THESE ARE THE SCHEMATICS FOR COMBO STAR Vers "BB"

COMBO STAR

COMMERCIAL-IN-CONFIDENCE NOT TO BE DISCLOSED WITHOUT WRITTEN AUTHORITY			
Title:			
PCB file name:			
Size:	A3	Number:	
Issue:			
Printed on:	5-Jul-2010 10:00:08	Sheet	1 of 16
File:	H:\COMBO-SCHEMATIC-PROJECT-1211109\COMBO_PICASTAR_Vers_BB_111109.prj

Sheet:	SCHEMATICS BY VK3PE & C.S.	
5	TITLE:- H:COMBO-SCHEMATIC-PROJECT-121109/COMBO-DSP_MBD.sch FOR PANEL	
of	16	
	"VK3PE"	Vers

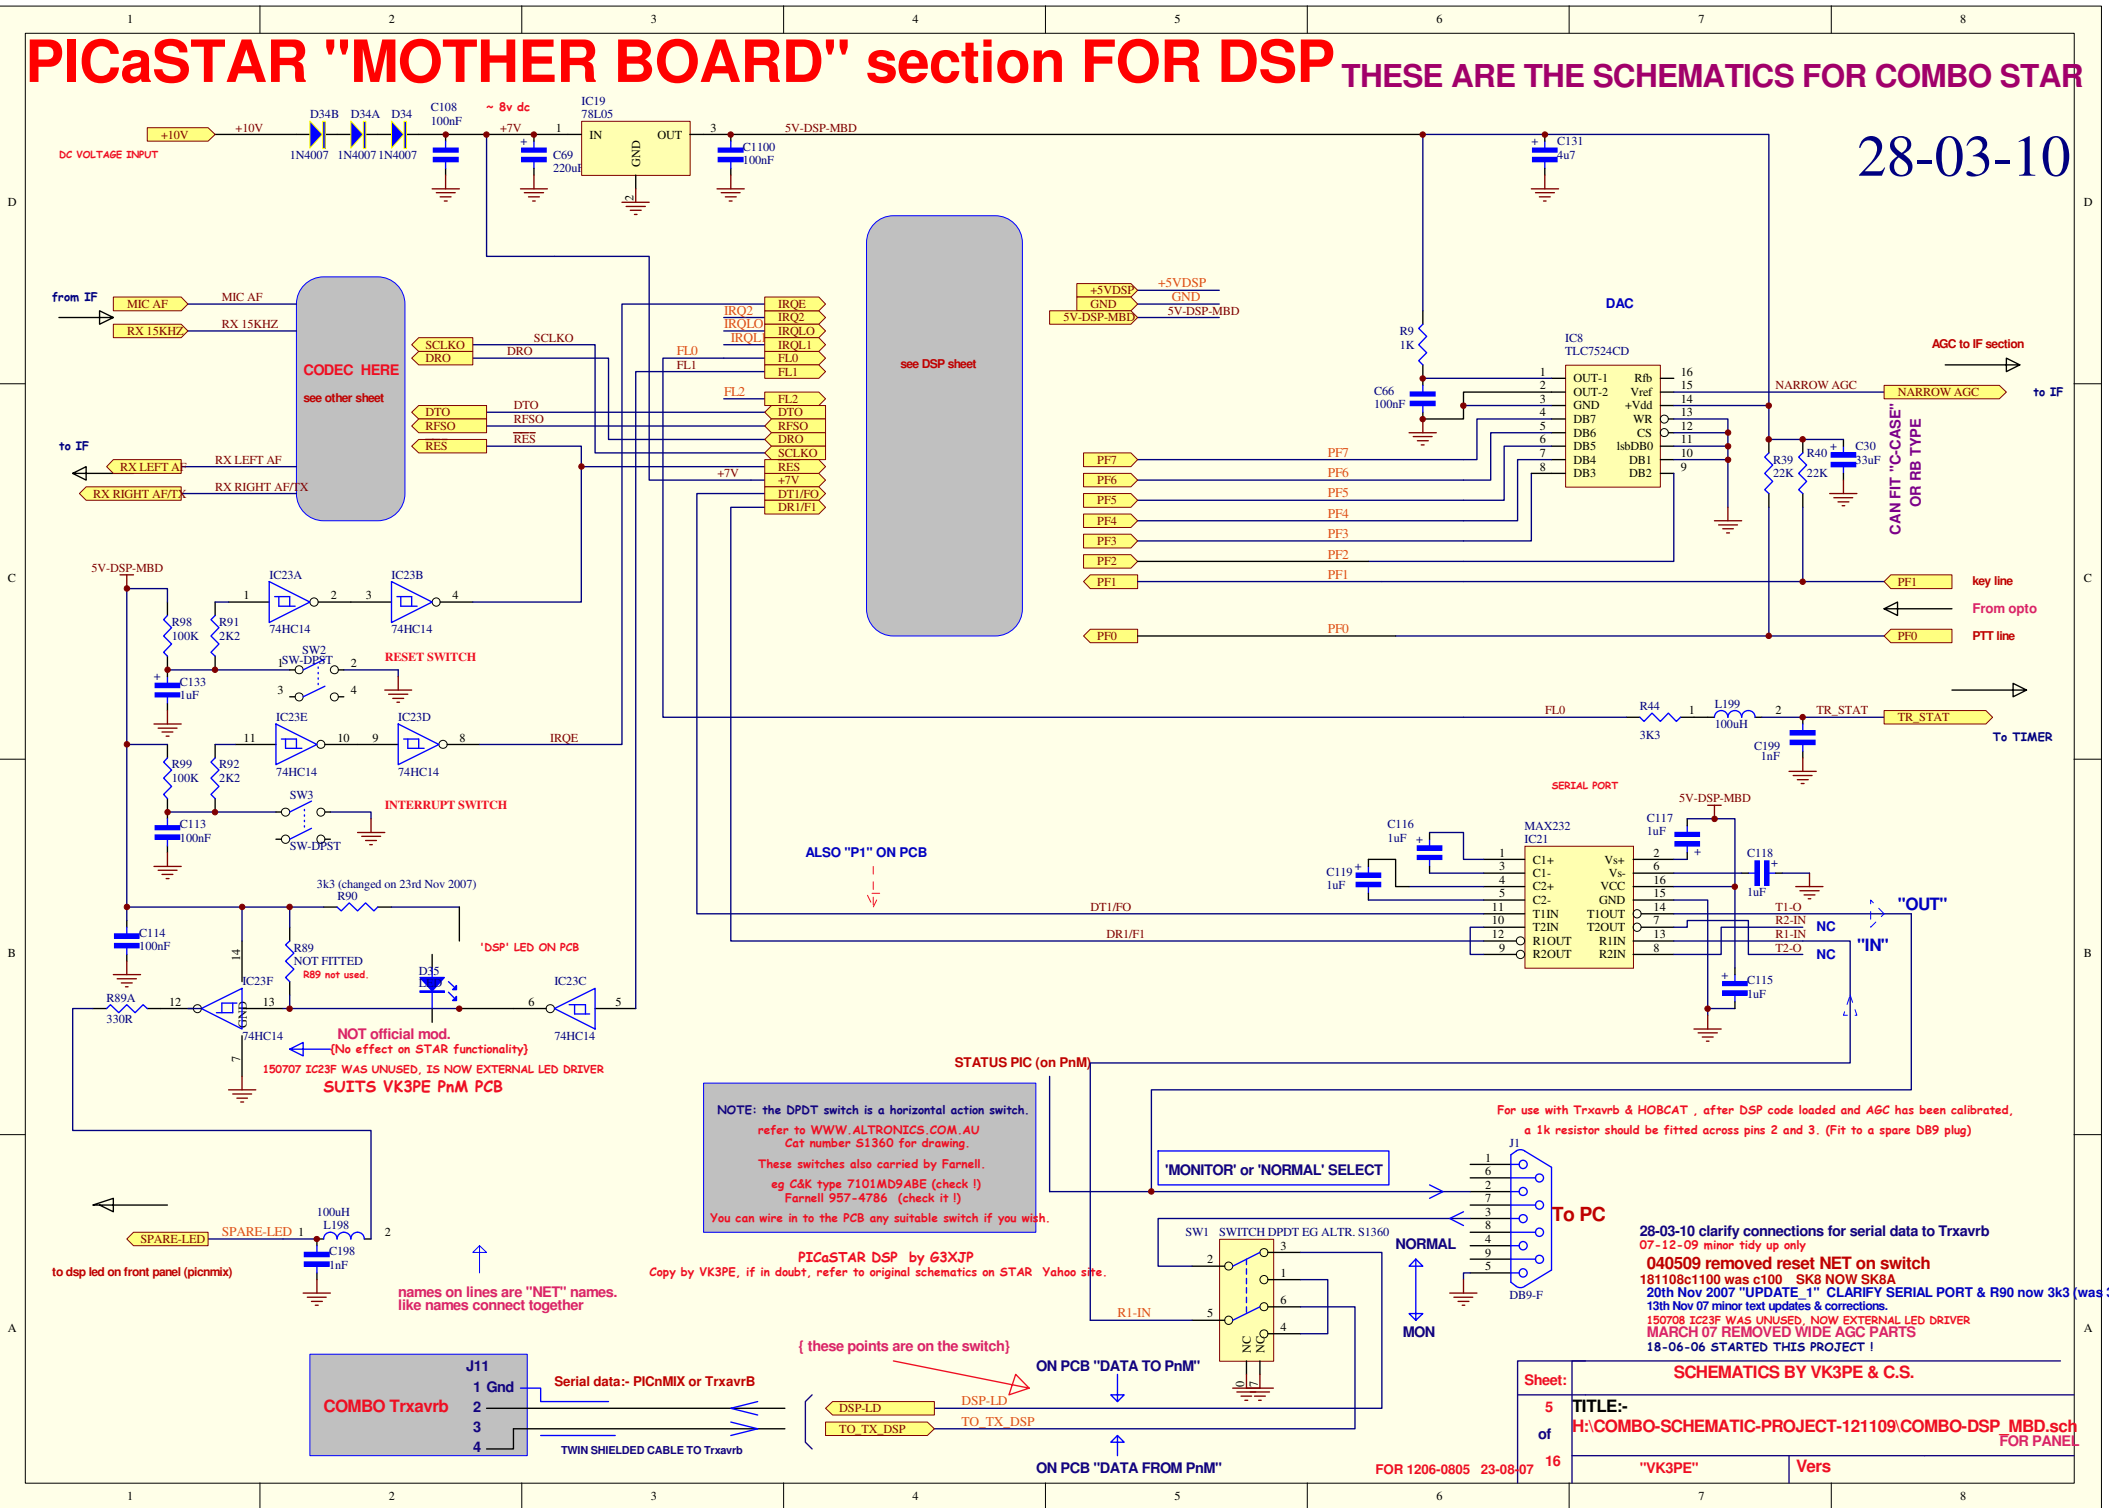
DSP motherboard, (sheet 5) The RS232 switch Farnell part number has been corrected. Please verify all numbers given in these documents though by checking Data sheets etc.

The DSP motherboard area (sheet 5) has been updated to clarify the connections from the Serial Data switch routing to the Trxavrb PCB (or PICnMIX if used) See bottom area of the sheet.

28-03-10 clarify connections for serial data to TrxavrB
07-12-09 minor tidy up only
040509 removed reset NET on switch
181108c1100 was c100 SK8 NOW SK8A
20th Nov 2007 "UPDATE_1" CLARIFY SERIAL PORT & R90 now 3k3 (was 330R)
13th Nov 07 minor text updates & corrections.
150708 IC23F WAS UNUSED, NOW EXTERNAL LED DRIVER
MARCH 07 REMOVED WIDE AGC PARTS
18-06-06 STARTED THIS PROJECT!

PICASTAR BPF SECTION, sheet 1 of 3

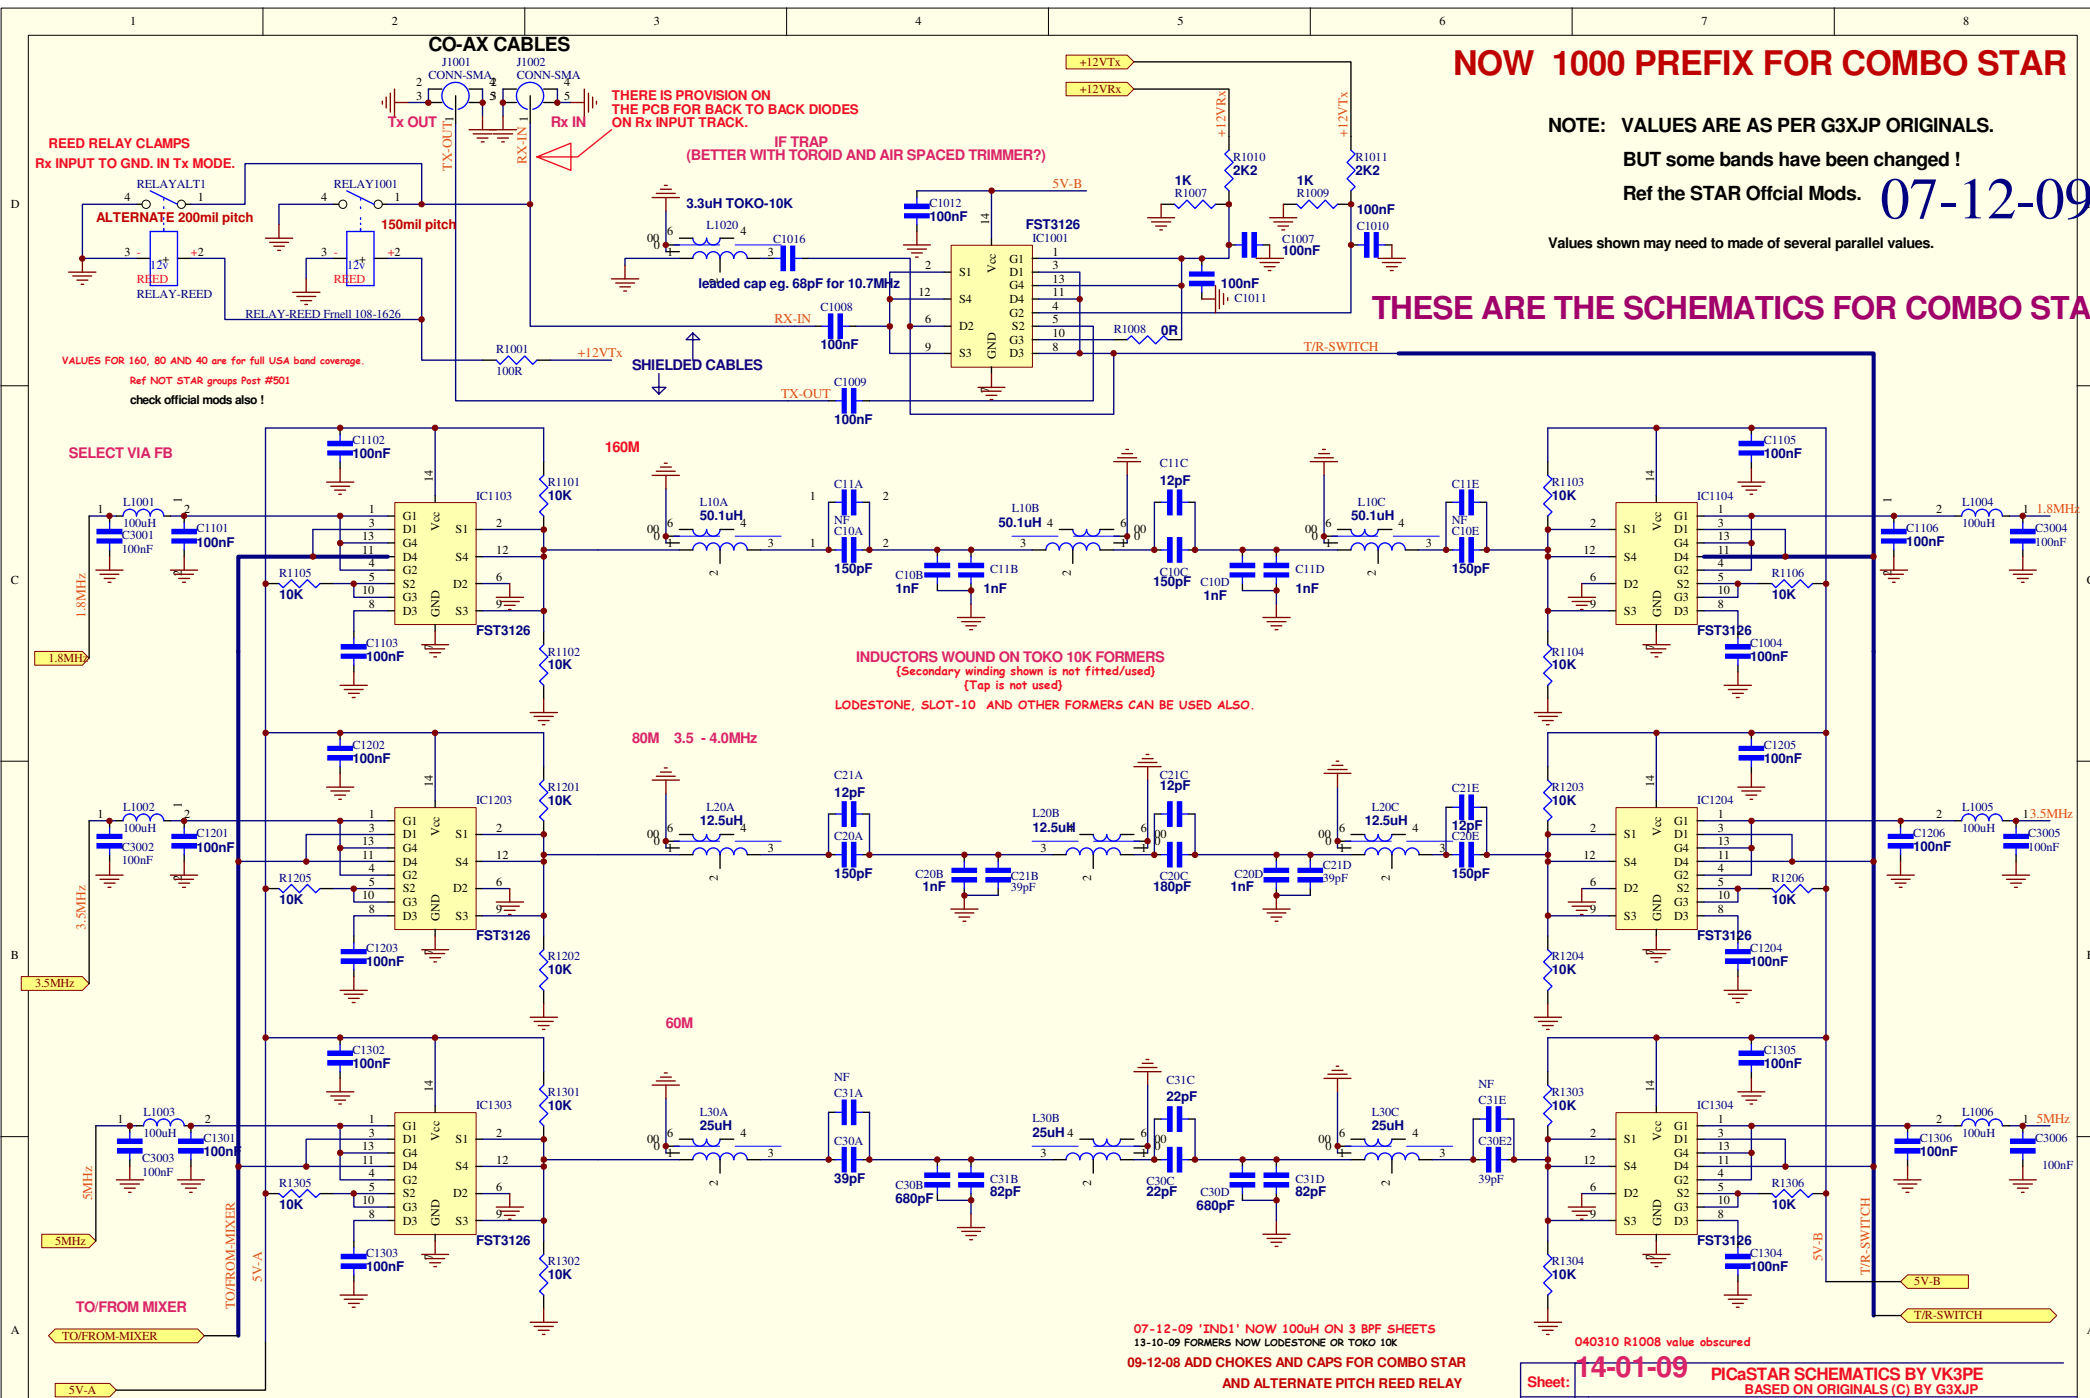
Please also note that the 0603 LED's fitted to the PCB, in the BPF area do NOT all run in the same direction.

The LED for wide-band is fitted reverse to all of the others.

040310 R1008 value obscured

Sheet:	8	
of	16	
TITLE:-	COMBO SCHEMATIC FOR PICaSTAR MAGIC ROUNDABOUT	
File:	COMBO-MR.sch	
Author:	VK3PE	
Vers	Ver A panel

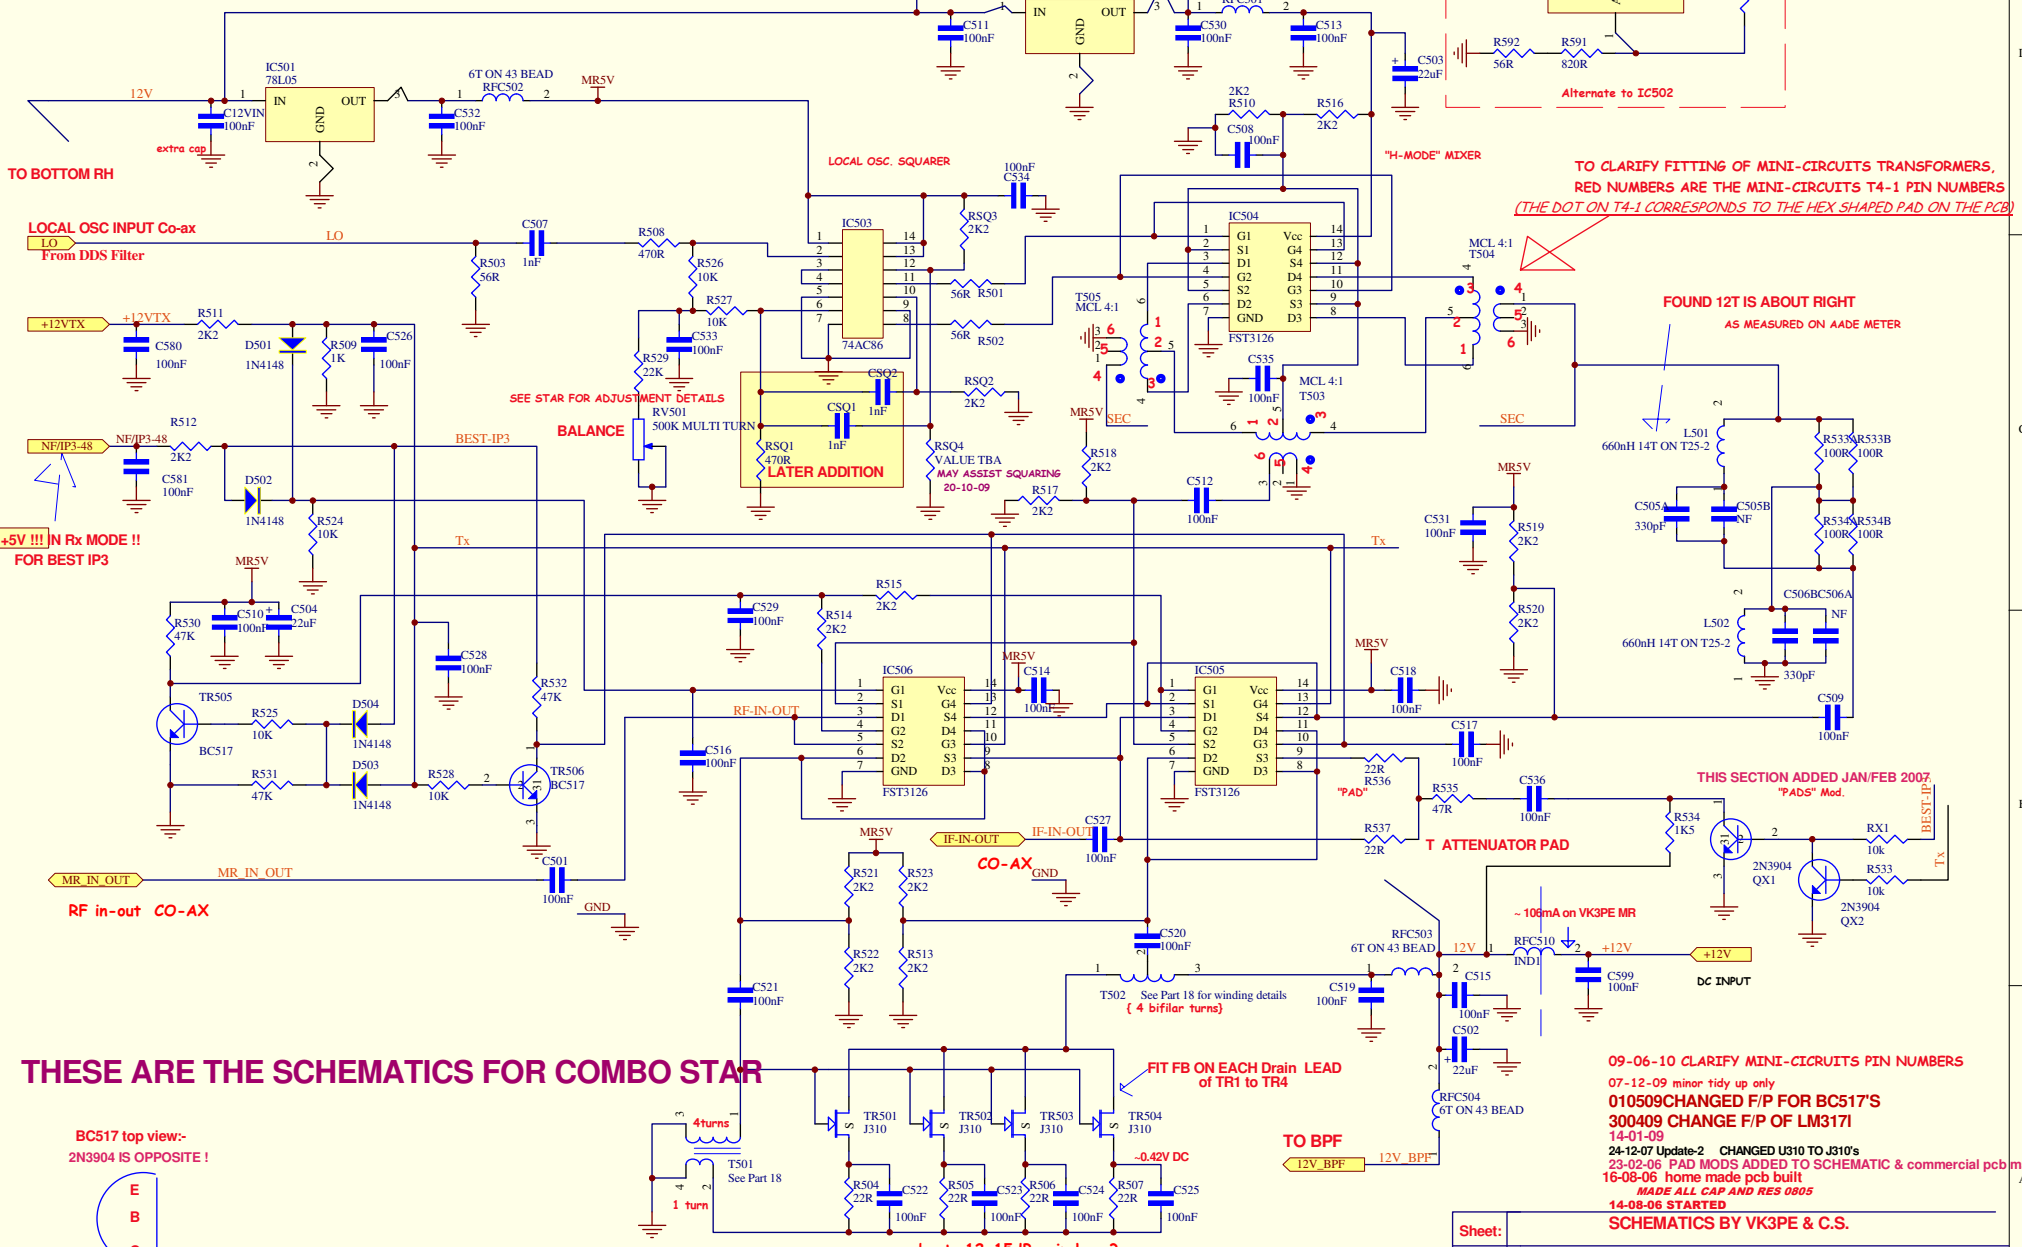
Clarified pinout of the Mini-Circuits T4-1 transformers in Magic Roundabout, sheet 8. (added pin numbers in red, of the T4-1, to the transformers. Also, a note in top right corner.)

TO CLARIFY FITTING OF MINI-CIRCUITS TRANSFORMERS, RED NUMBERS ARE THE MINI-CIRCUITS T4-1 PIN NUMBERS (THE DOT ON T4-1 CORRESPONDS TO THE HEX SHAPED PAD ON THE PCB)
